APPENDIX E

WRITTEN AGENCY COMMENTS

**Comments on the
Draft Environmental Impact Statement
THE PRESERVE AT INDIAN HILLS
TOWN OF HUNTINGTON, SUFFOLK COUNTY, NEW YORK**

*December 6, 2019
By Christian Granelli, Senior Environmental Planner*

Map Amendment to NYS Regulated Freshwater Wetland N-8

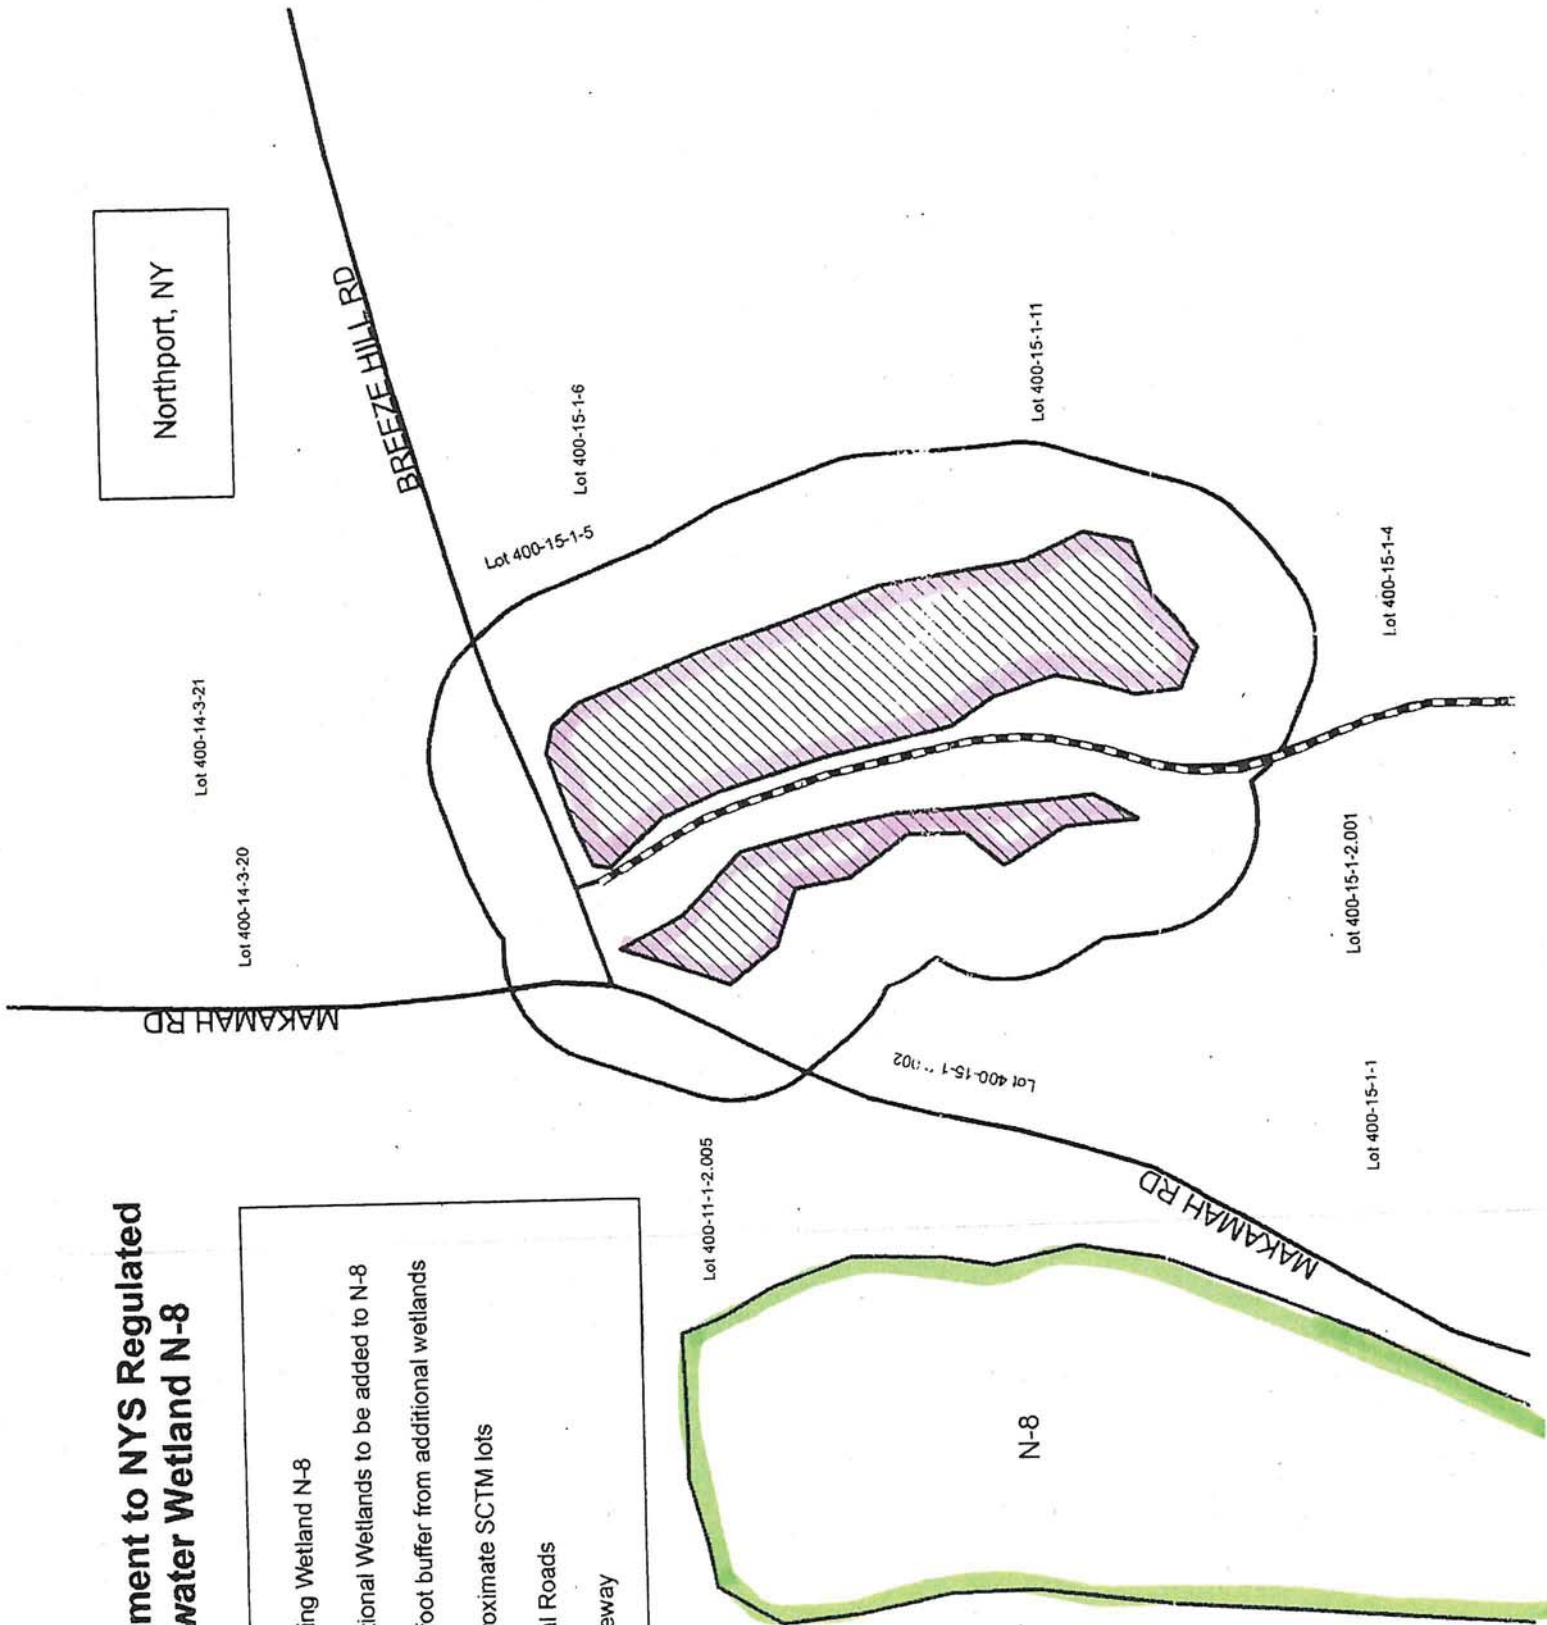
- Figure 2-4 NYSDEC Wetlands Map does not include the proposed map amendment as per the August 14, 2017 letter to the Town Supervisor (enclosed)
- Figure 2-8 Habitat Map does not include the parcel to the south west immediately adjacent to Makamah Road.

- Revise Figure 2-4 NYS DEC Wetlands Map in accordance with the NYSDEC letter, dated October 16, 2019, indicating the proposed map amendment of freshwater wetland N-8. E-238
